Technical Memorandum

TO: Mr. Alan Day, General Manager
Brazos Valley Groundwater Conservation District

SUBJECT: Review of the City of College Station Simsboro Aquifer Evaluation Report

DATE: August 1, 2023

Figure 1. Proposed City of College Station Well Location Map

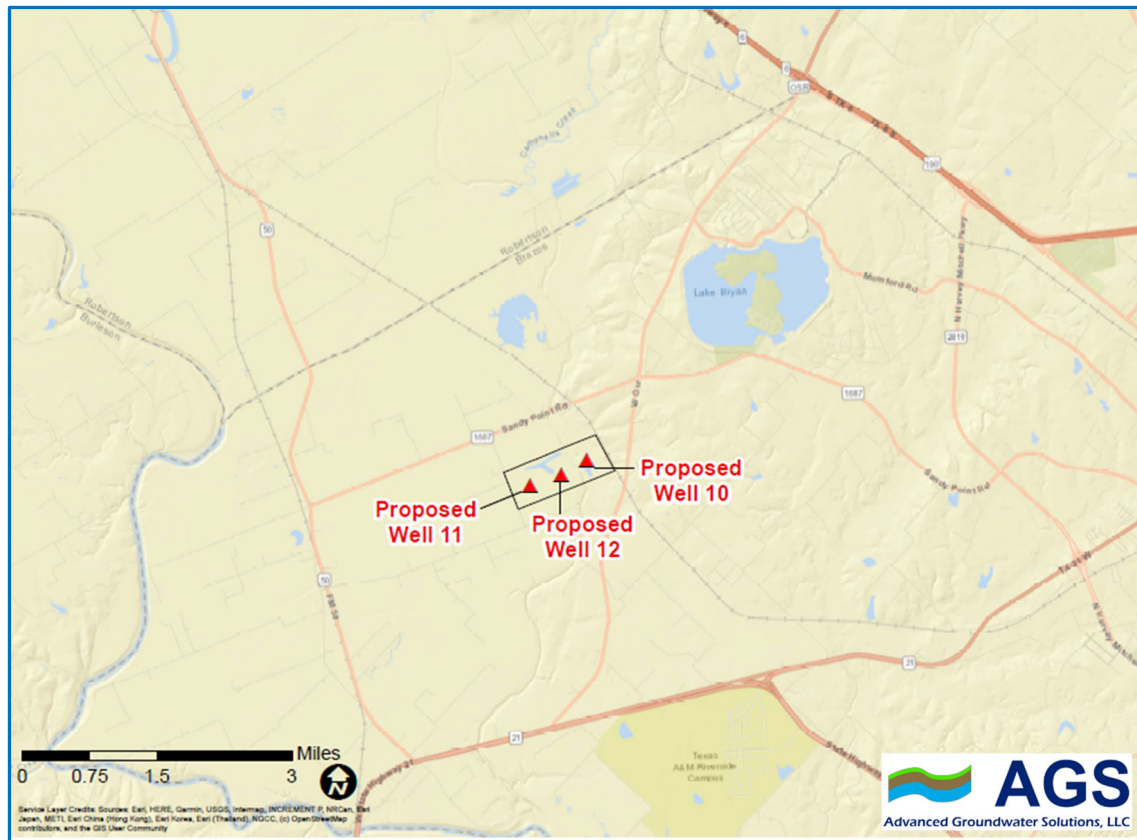
The proposed well locations are shown on Figure 1 below with the wells located about 1 to 1.5 miles south-southwest of the intersection of Farm-to-Market Road 1687 and Old San Antonio Road (OSR) in west Brazos County.

The proposed locations of the three City of College Station wells are shown on Figure 1 below.

Figure 2. Projected GMA 12 2021 Planning Cycle DFC Water Level Decline at Proposed College Station Wells 10, 11 and 12.

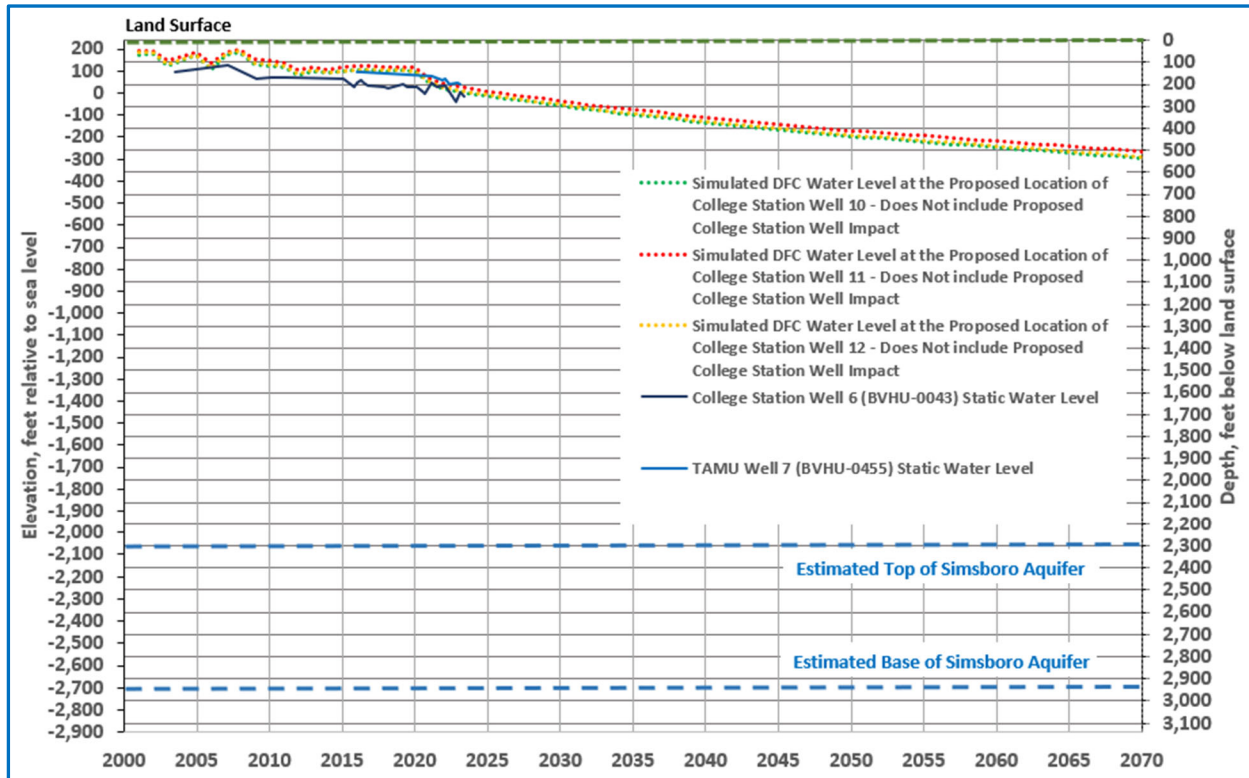
As a way of evaluating potential long-term estimated water level decline at the proposed College Station wells, AGS plotted the simulated water level decline at each well location based on the 2021 GMA 12 DFC/Modeled Available Groundwater (MAG) projections for the Simsboro Aquifer as shown on Figure 2 below. The water level projections shown in the figure below are from the TWDB approved DFC/MAG run known as GMA 12 “S-19”, but do not include the local impacts from the proposed College Station wells included in the AER, nor do they include all of the pumping from the Simsboro Aquifer that has been permitted in the area in the past year. The DFC run includes pumping estimates from the Groundwater Conservation Districts in GMA 12 as of about December 2021 that yield DFCs so that the TWDB can estimate the MAG. The detailed assumptions for the DFC simulation can be found in the GMA 12 Explanatory Report (Daniel B. Stephens & Associates and others, 2022) and documentation of the TWDB MAG run can be found in GAM Run 21-017 MAG: Modeled Available Groundwater for the Aquifers in Groundwater Management Area 12 (Shi and Harding, 2022).

The graph illustrates the relationship between the land surface, estimated static water level through time and the estimated top and bottom of the Simsboro Aquifer based on review of available electric logs near the proposed well locations.

Historical static water level measurements are also shown on Figure 2 for the City of College Station Well 6 (BVHU-0043), which is located about 0.75 miles to the north of proposed College Station Well 10 and screen sands of the Simsboro Aquifer in the depth interval of about 2,352 to 2,876 feet below land surface. Historical Texas A&M University Well 7 (BVGCD Permit BVHU-0455) static water levels are shown on Figure 2 and the well screen sands of the Simsboro Aquifer in the depth interval of about 2,395 to 2,945 feet below land surface. BVHU-0455 is located about 1.5 miles south of proposed College Station Well 10.

Available drawdown in wells in the Simsboro Aquifer will decline over time based on the DFC simulation. In other words, the red, orange and green dashed lines do not include the impact of the proposed College Station wells. Although not evaluated or discussed in detail herein, these levels of water level decline in wells and artesian head decline in the aquifer will have some impact on vertical leakage, intercepted discharge, reduction in confined and unconfined storage, and potential flow directions in the aquifer. Pumping by the proposed wells will have some of the same type effects on the aquifer.

Figure 3. GAM Simulated Drawdown as a result of Aggregated Pumping 5,065 ac-ft/yr for 10 Years

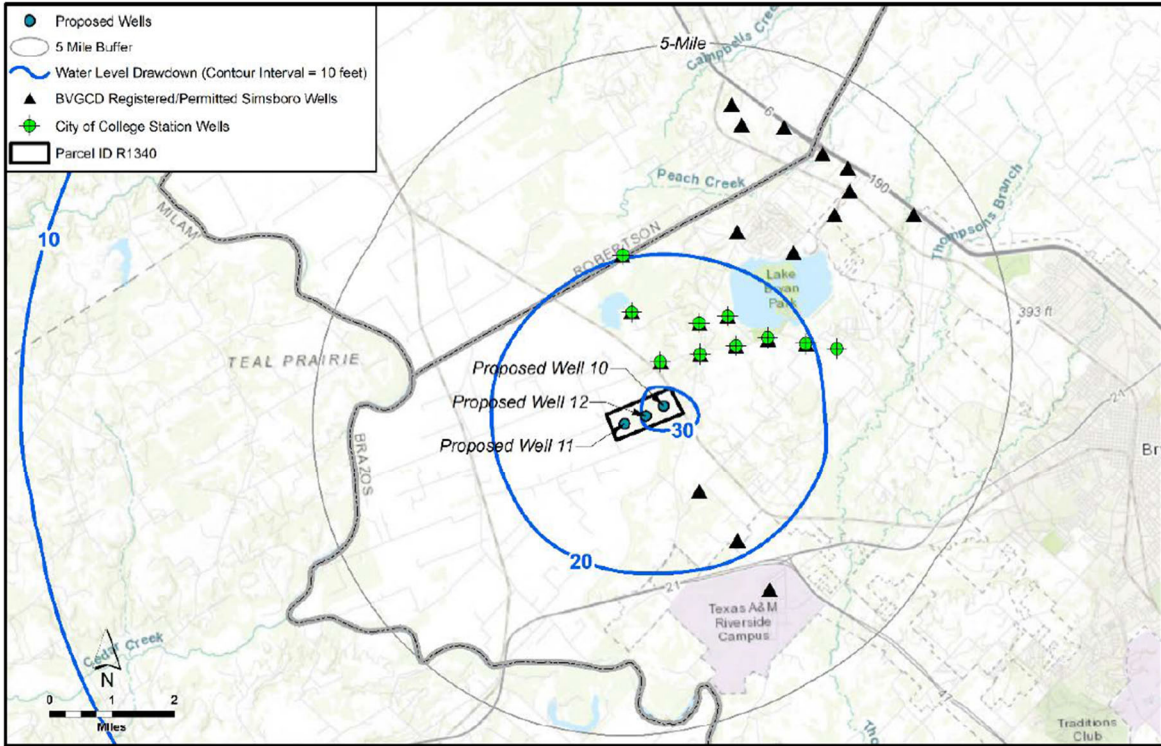
RWHA used the TWDB Central Portion of the Sparta, Queen City and Carrizo-Wilcox Aquifer GAM to estimate drawdown that results from continuously pumping the proposed City of College Station wells at a combined rate of 5,065 ac-ft/yr for 1 year and 10 years. A copy of the RWHA 1-year and 10-year GAM simulated interference drawdown illustrations from the AER (RWHA Figures 2 and 3) are attached to this memorandum.

AGS was able to verify the RWHA GAM simulations using methodology described in the AER to isolate the pumping effects of the proposed College Station wells.
